Access Compliance Report Public Rights-of-Way (Pedestrian Signals)

Main Street: **DANA_POINT_HARBOR_DR** Cross Street: **CASITAS_PL** Location: **SE**

ADA ID: **SGRK220208170344** Signal Type: **One Push Button-Non APS** Overall Compliance: **No** Severity Scores: **BTN 1: 25** **BTN 2: N/A** **No BTN: N/A**

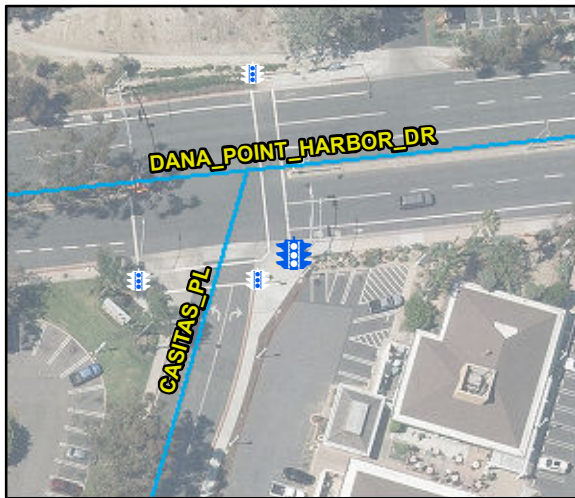
OC Std/PROW: R404.2

Possible Solutions: Remove and Replace Clear Space.
